Development Review Comments

2026-103-PAM

WESTAT REDEVELOPMENT

PRE-APPLICATION MEETING SITE PLAN

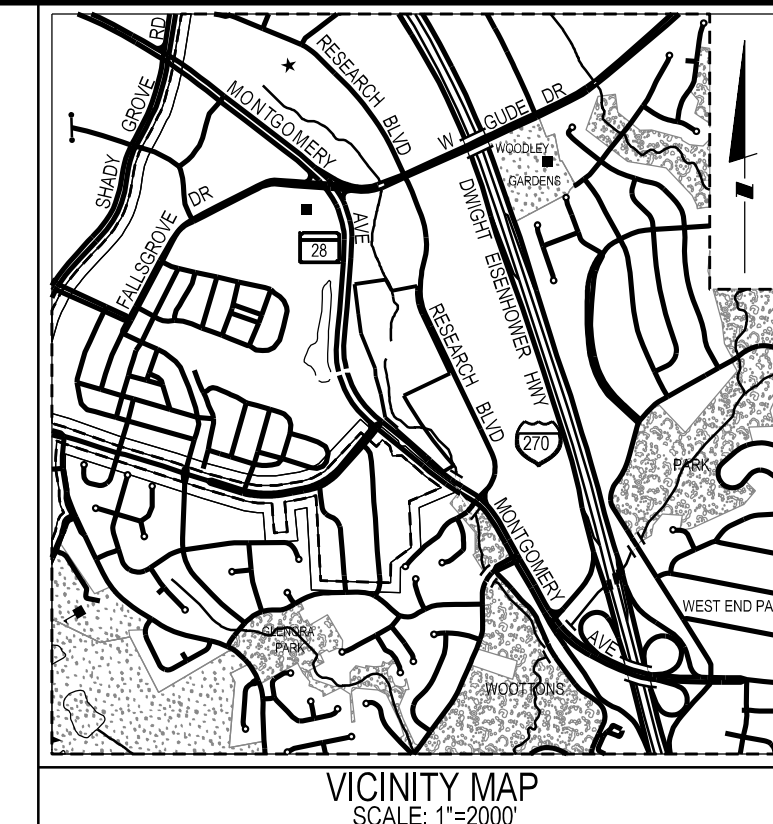
Please indicate the location of the department key access box for each structure.
The existing hydrant located on Frederick Avenue is located in a high speed (40 mph) roadway, which is not an appropriate location for a department key access box. The department key access box would place the department personnel in jeopardy.
We recommend relocating the fire department connection (FDC) for the Lidl site to within 100 ft. of the additional hydrant in the parking lot adjacent to the Lidl site within 100 ft. of the FDC.
The fire flow calculations will be a condition of building plan submission.

Added per request

FDC relocated per request

acknowledged

COVER SHEET
PRE-APPLICATION MEETING SITE PLAN
WESTAT

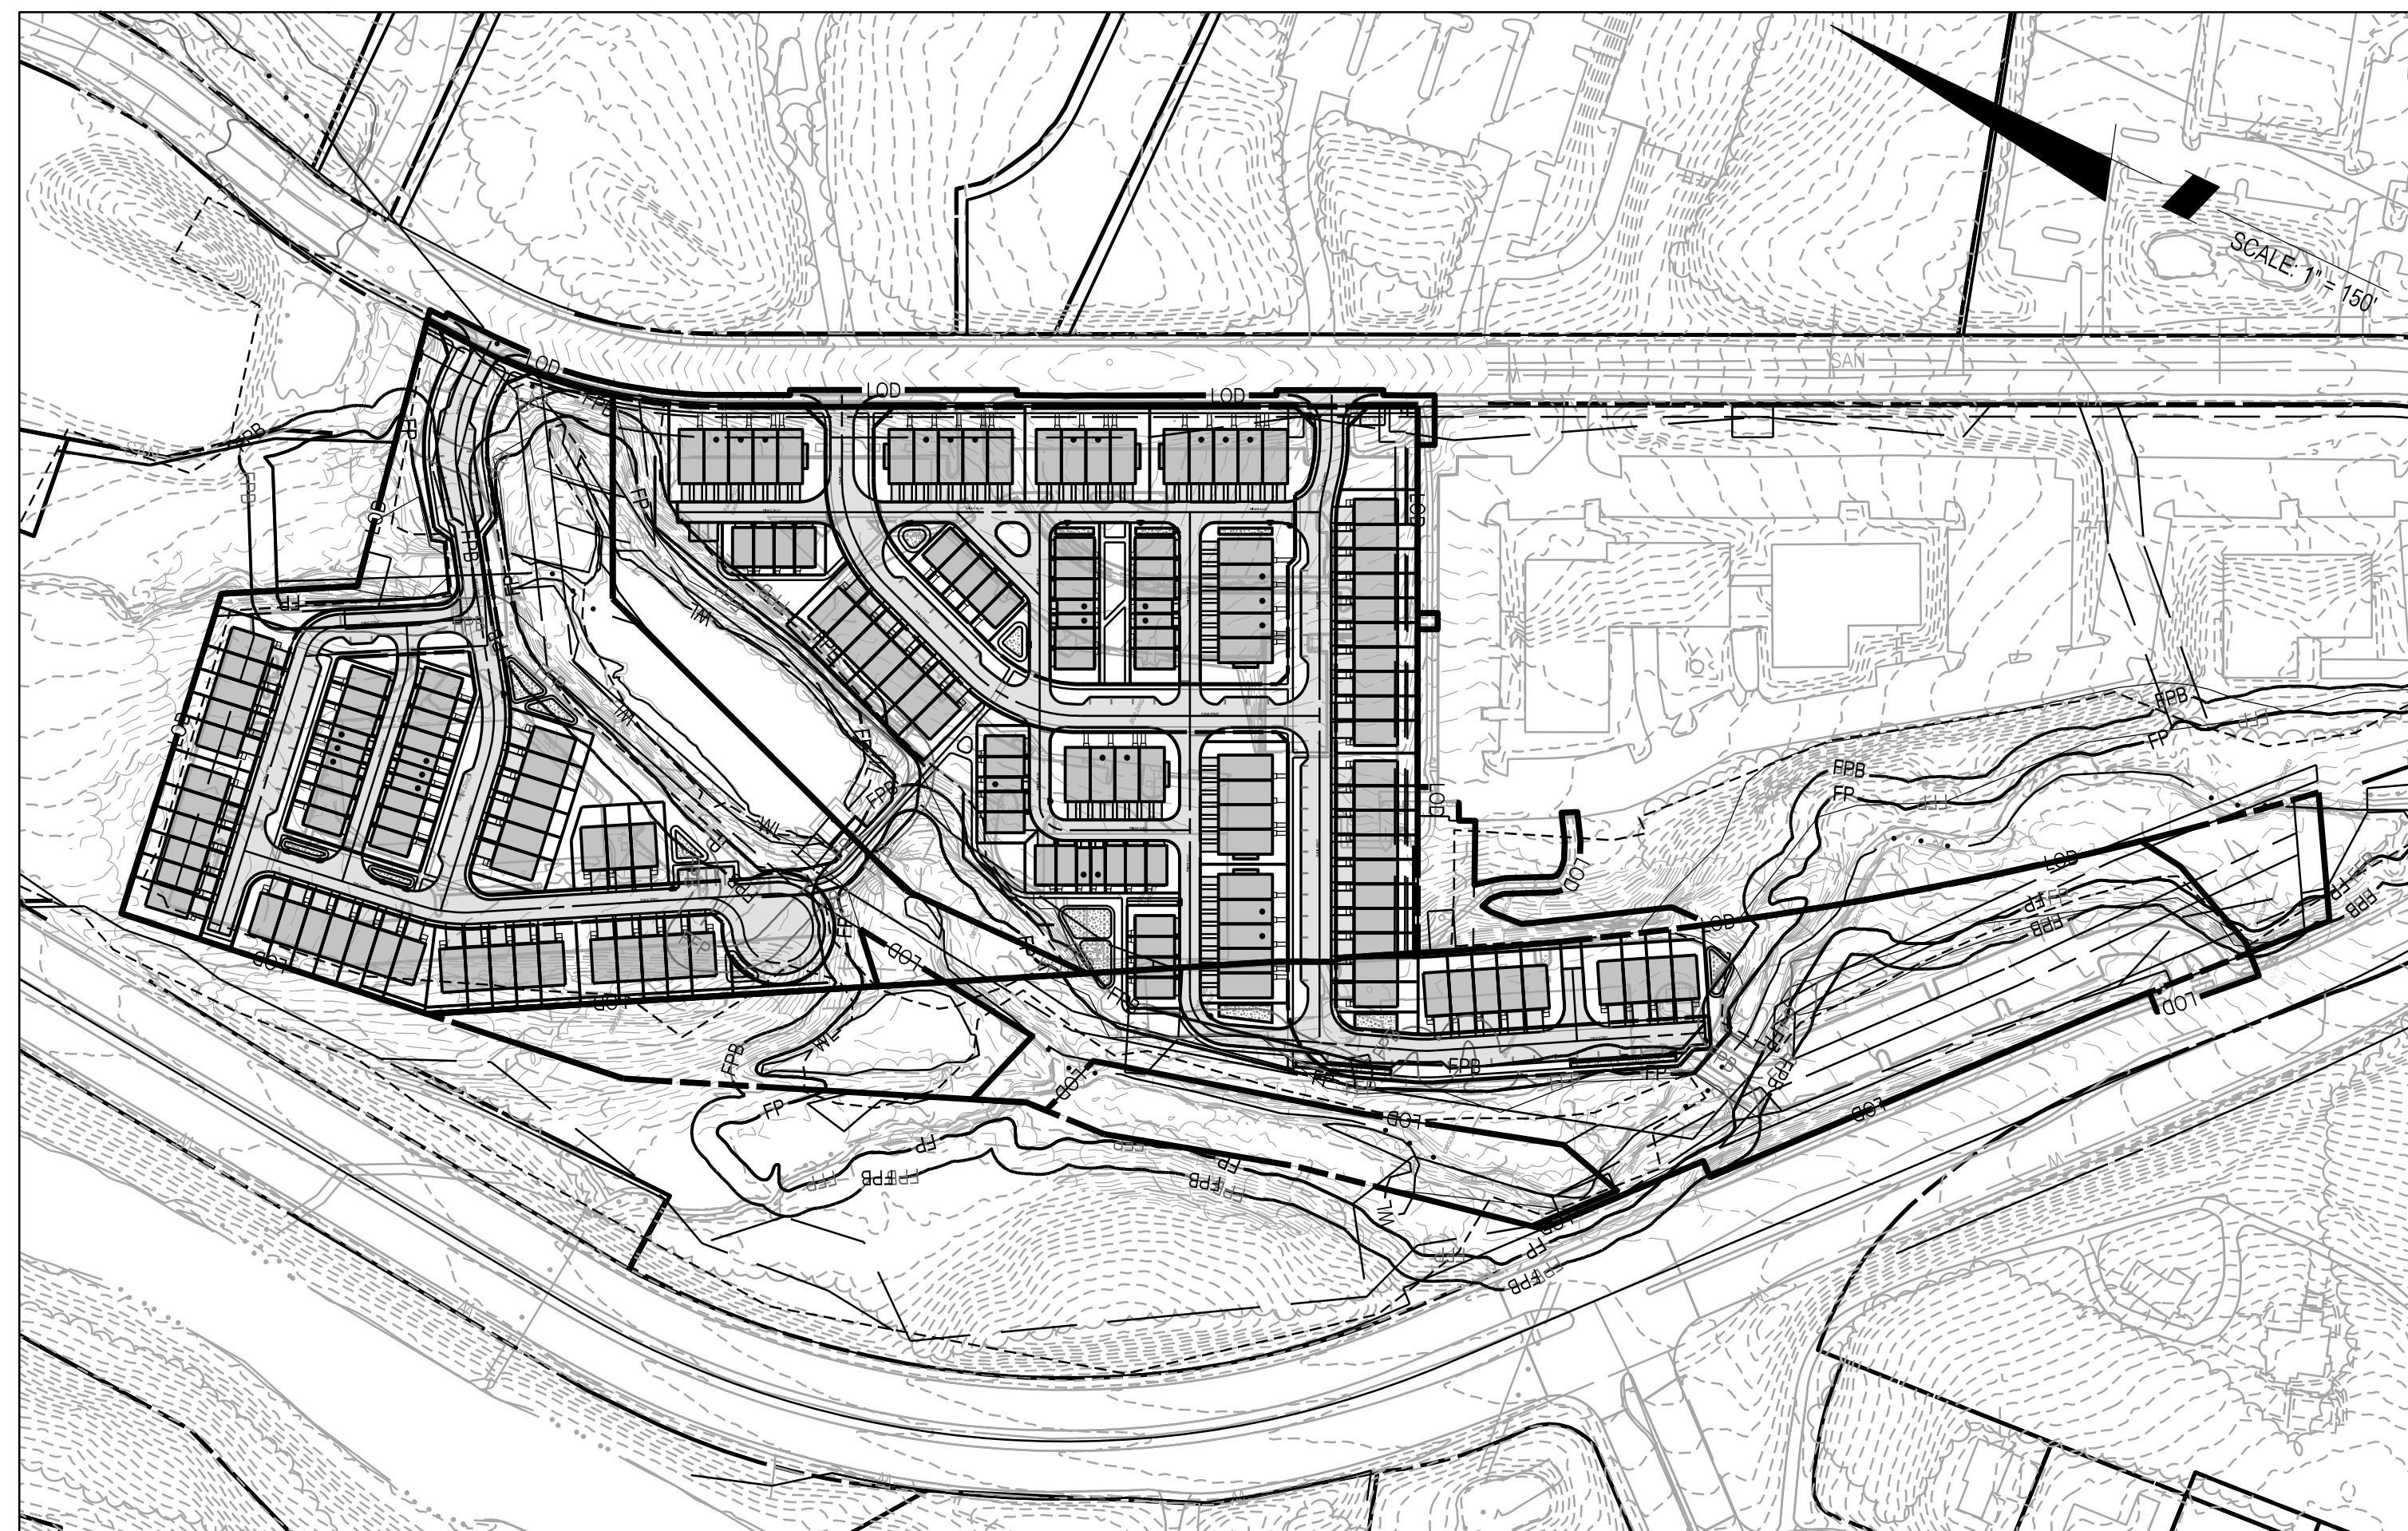
Please provide an exhibit that details the proposed improvements atop the existing impervious areas. Please utilize linework hierarchy. Please highlight the portions of the proposed improvements that encroach past existing impervious area.

Please provide color coded hatching and symbology for environmentally sensitive features such as forest conservation easements, forested areas (not under FCE), floodplains, floodplain buffers, wetlands, wetland buffers, streams, and stream valley buffers.

Please remove other linework that isn't necessary for this exhibit.

Provide a fire protection site plan.
-Fire Protection Site Plan Requirements:
<https://www.rockvillemd.gov/documentcenter/view/481>

Provide layout per ordinance 25.17.03a. All underground lines and cables shall be placed in a public utility easement, or otherwise on private property. No utilities may be placed in the public right-of-way or on City property without the express written permission of the City, and subject to such terms and conditions that the City may require.

Dry utilities may cross the ROW perpendicular. Applicant will need to submit a conceptual dry utility plan to be approved by both the utility companies and DPW.

b. Generally dead-end water mains should be avoided.

c. The City generally follows WSSC Pipeline Design Manual for sizing, structures, clearances, crossings etc.

d. Public water and sewer mains should not be located within SWM easements.

e. Prefer mains be located under pavement rather than mews/open space.

The minimum easement width for a normal (14-inch diameter or less) pipeline (water or sewer at normal depth) is 20-feet. When both water and sewer (normal diameter and depth) are installed in the same easement, the minimum width is 30-feet. Installation of deep or large water/sewer will require additional easement width.

The minimum horizontal clearance from a building to the outside diameter of a W&S main is 15-feet. The minimum spacing between adjacent buildings with both water and sewer lines between them must be 40-feet. In some cases where connections, fire hydrants, or deep water/sewer lines are involved, additional easement width is required.

Balconies or other building appendances must not encroach within easements. W&S pipeline alignment should maintain a minimum 5-foot horizontal clearance from storm-drain pipes, structures and other utilities.

f. Water modeling is likely necessary due to the site's proximity to the Oak Knoll sampling station, known to have water age issues. Water demand is also proposed to decrease which will inversely increase water age.

1. This project must abide Forest Conservation (retention, reforestation, and/or afforestation) and significant tree replacement requirements applicable to MXE zones as outlined in Chapter 10.5.

2. This site contains high priority retention areas such as stream buffers, wetlands, steep slopes, and specimen trees that may impact forestry requirements on site.

4. All newly subdivided lots must provide lot trees in accordance with 25.21.21 of the Zoning Ordinance.

5. All newly subdivided lots fronting public right of way must provide street trees in accordance with 25.21.21 of the Zoning Ordinance. Please provide linear calculations demonstrating compliance with 1 street tree per 40' requirement.

6. Trees shall be a minimum of 5 feet from inlets and manholes.

7. Shade trees shall be spaced a minimum of 7 feet from micro-bioretenion underdrain pipes (6" diameter and smaller) and ornamental tree to be spaced 5 feet minimum.

1. The minimum offset from curb line extended shall be minimum 30 feet where no traffic control is present, and minimum 50 feet where traffic control is present. Traffic control can consist of stop signs, traffic signals or any other measure in place to provide safe roadway operations. An increase to this minimum offset is at the discretion of the Director of Public Works.

2. No tree is permitted within the line of sight.

Provide sight distance for streets and alleys.

Streets & alleys must be laid out so required sight distance is provided.

Please note all new record lots created by the proposed development must meet the setback requirements and other development standards of the MXE Zone as specified in Sec. 25.13.05.b.1.

Per Sec. 25.17.05.b and 25.13.06.c.5, internal sidewalks must be provided with a width of 6 feet unless justification is provided as to why an alternative width is proposed and why the directed width is not being provided.

Provide an exhibit which demonstrate the distribution of townhouses vs. two-over-two units.

If collective mailboxes are to be utilized, show location(s) on the site plan.

All ROW must be public and must meet a city standard road section. If proposing a road section with parking only provided on one side must demonstrate adequate parking is provided. Roads sections may require M&C approval.

All ramps should be perpendicular to the road crossing.

Staff will not support street grades greater than 5% unless there is a physical constraint preventing the installation. Adequate justification to support any grades that exceed ADA requirements will need to be provided. The cost or the loss of units is not adequate justification.

All new streets (and sidewalks) be designed with a max. 5% grade (4.5% to provide construction tolerance) to the maximum extent practicable so as to meet ADA standards. City standard details for secondary residential street requires a maximum roadway grade of 10% and notes that "[w]here the maximum roadway exceeds 5%, additional measures may be necessary to meet ADA requirements."

SITE PLAN

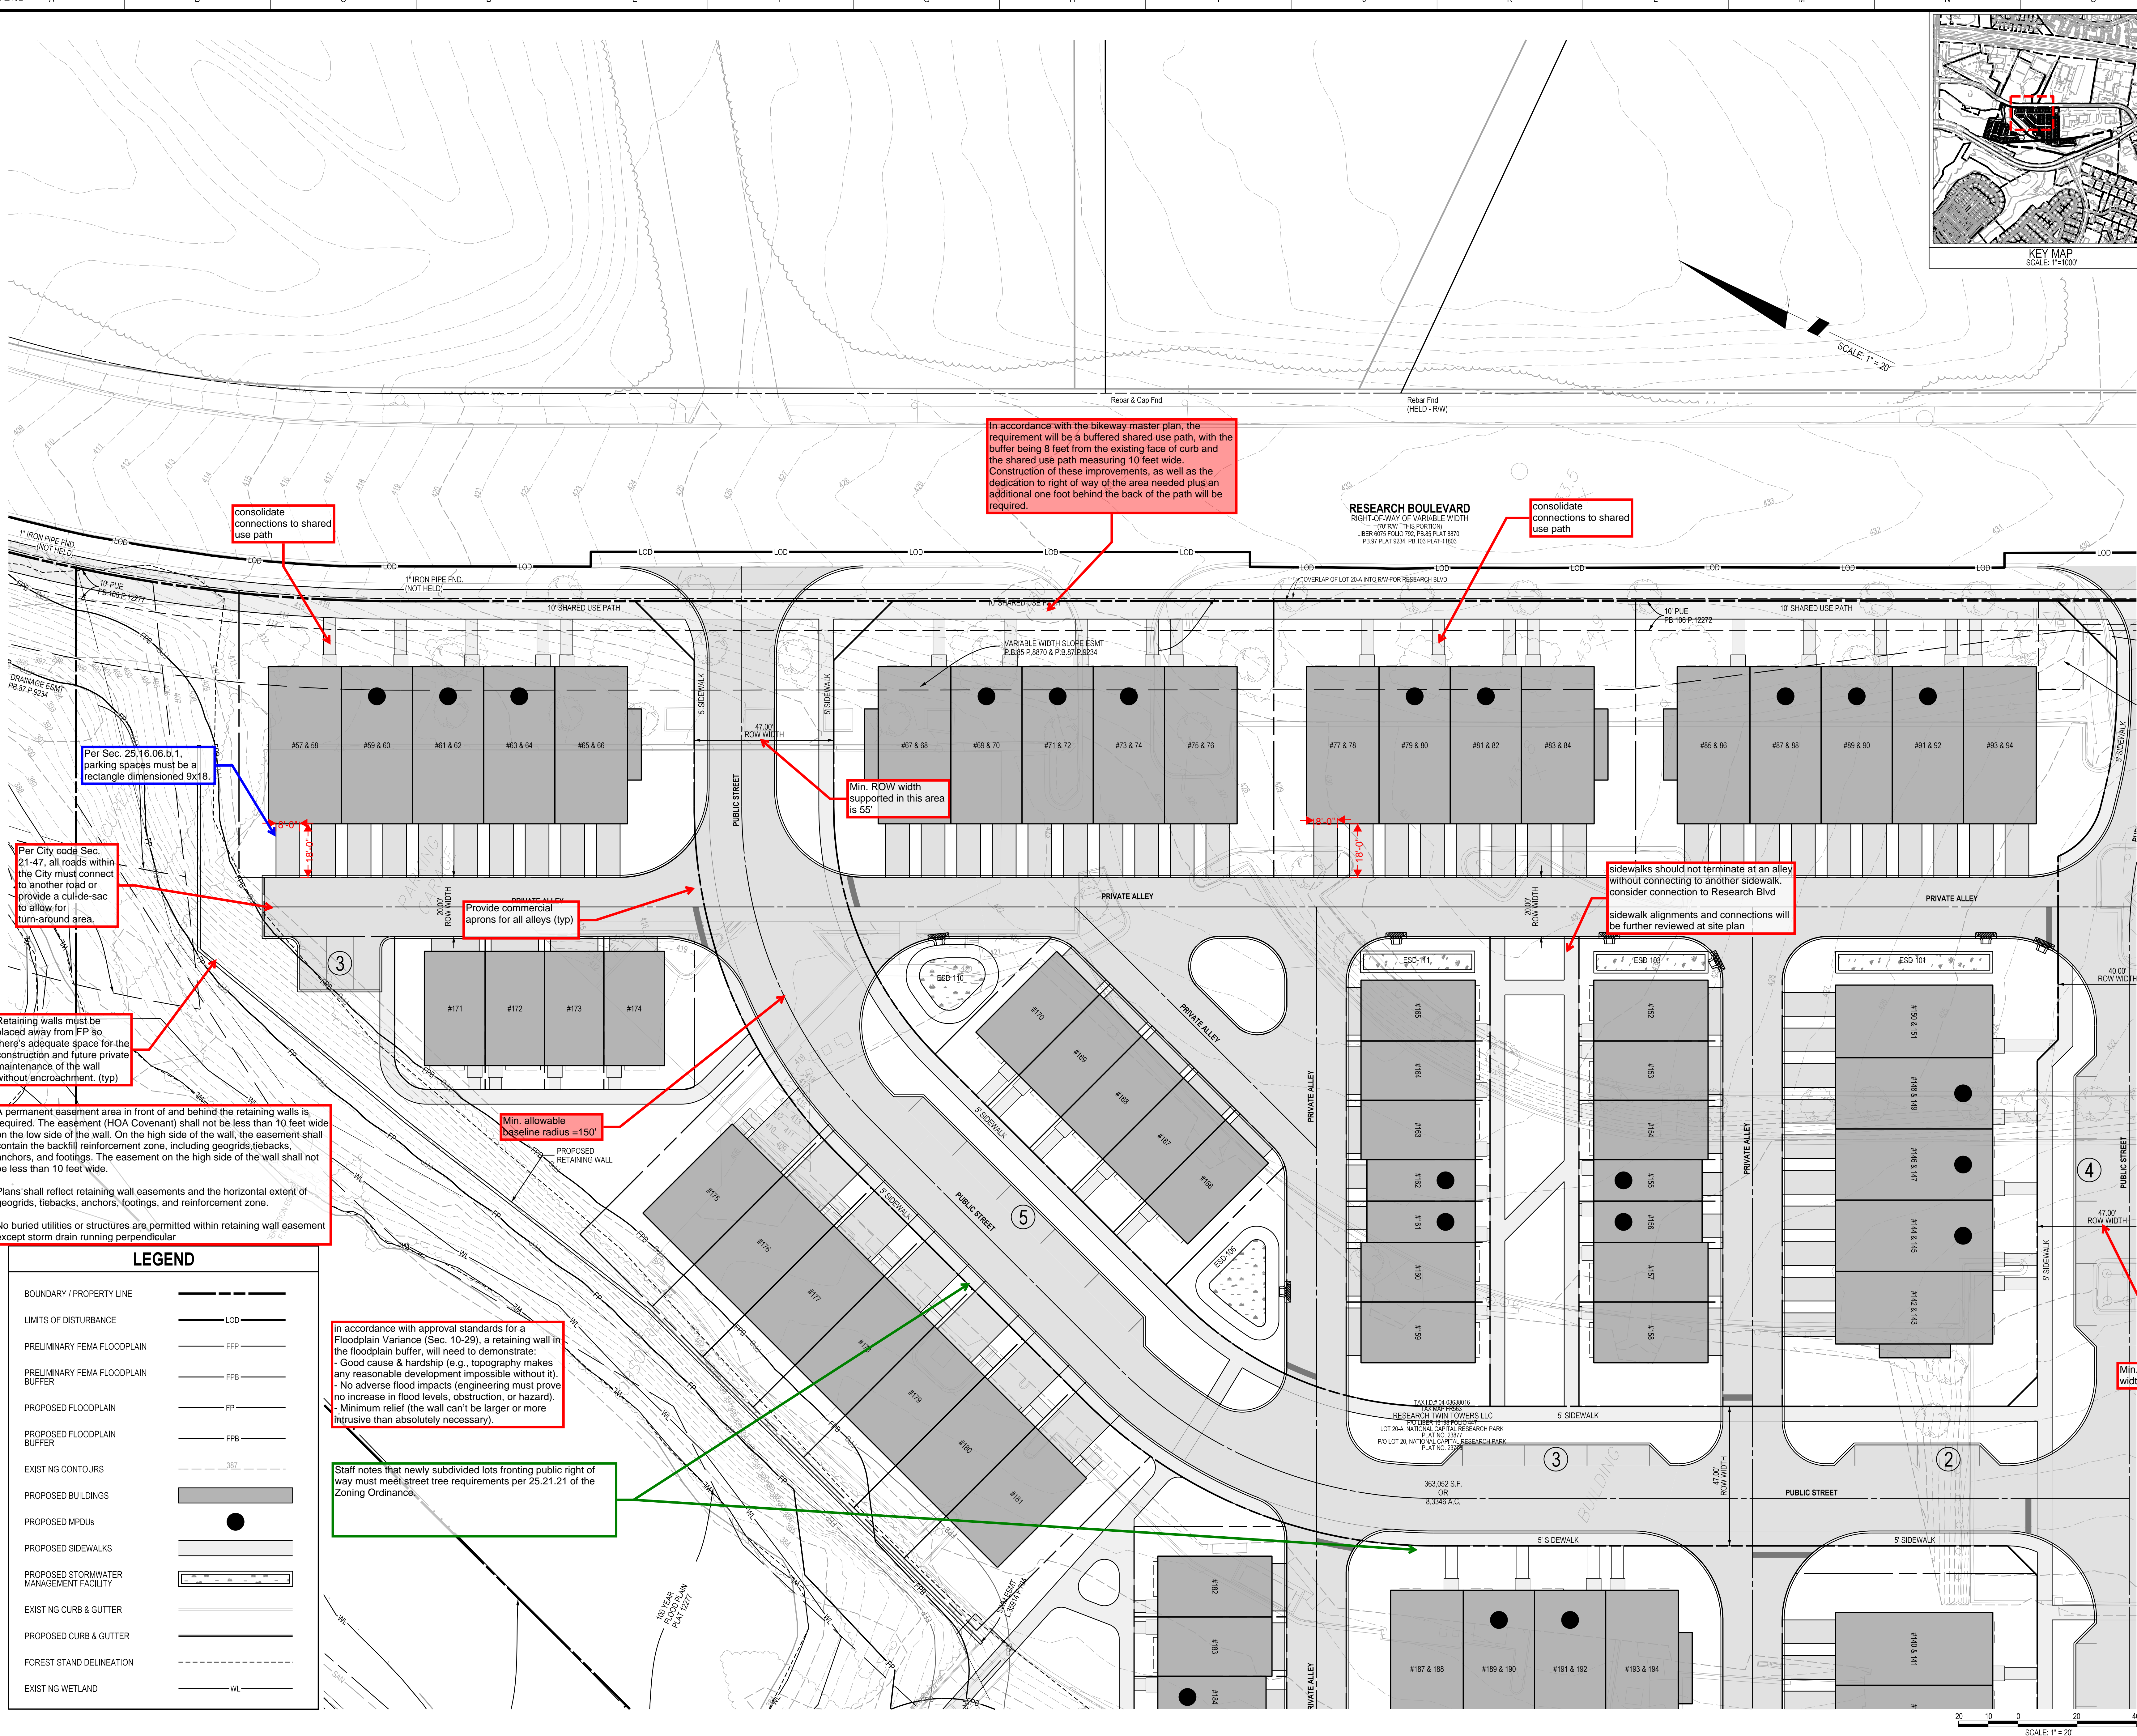
applicant (HOA) is required to develop an emergency evacuation plan, included with homeowner covenants, and notifying residents (and prospective residents) of the floodplain

LOD is depicted extending past the tree lawn on Research. Based on DPW comments, it seems impacts to street trees within the tree lawn are inevitable. Removals and replacements would likely be required. Existing street tree impacts, removals, and replacements must be reviewed by the City Forester, Paula Perez.

Show existing utilities and easements
Dead-end watermain are not allowed

In accordance with the bikeway master plan, the requirement will be a buffered shared use path, with the buffer being 8 feet from the existing face of curb and the shared use path measuring 10 feet wide. Construction of these improvements, as well as the dedication to right of way of the area needed plus an additional one foot behind the back of the path will be required.

verify existing utilities in PUE and determine whether additional easement is required after Research ROW dedication (typ)

consolidate connections from units to a private, parallel sidewalk, to shared use path

Subdivision access roads shall have the driving surface above the Base Flood Elevation and provide min. 2' Freeboard

Staff notes that newly subdivided lots fronting public right of way must meet street tree requirements per 25.21.21 of the Zoning Ordinance.

Add City of Rockville floodplain show updated NRI base

Please add stream valley buffer to the legend and throughout the plan in accordance with the NRI/FSD

The areas shown between driveways are not sufficient to support the required street trees

Min. Supported ROW width is 55' (typ). provide buffered sidewalks, etc.

Show culverts

provide ramps and crosswalk (typ)

SWM facilities should not be located in FB

Forestry
The City's Environmental Guidelines treat retaining walls as structures, and as such, they are not permitted within stream valley buffers except under very limited circumstances. The stream buffer is intended to remain undisturbed to protect water quality, habitat, and the stability of the stream valley.
If a retaining wall within the buffer is proposed, the applicant must demonstrate that:
1. No reasonable alternative exists to avoid the buffer;
2. The extent of encroachment has been minimized;
3. Sensitive areas (forest, wetlands, floodplain, steep slopes, rare species habitat) are avoided wherever possible; and
4. Mitigation measures (such as buffer averaging, reforestation, stream restoration, or other environmental enhancements) are provided to offset the impact.

Max. 10' aprons if meeting visitor parking (typ)

Min. allowable baseline radius = 150'

Show match lines (typ)
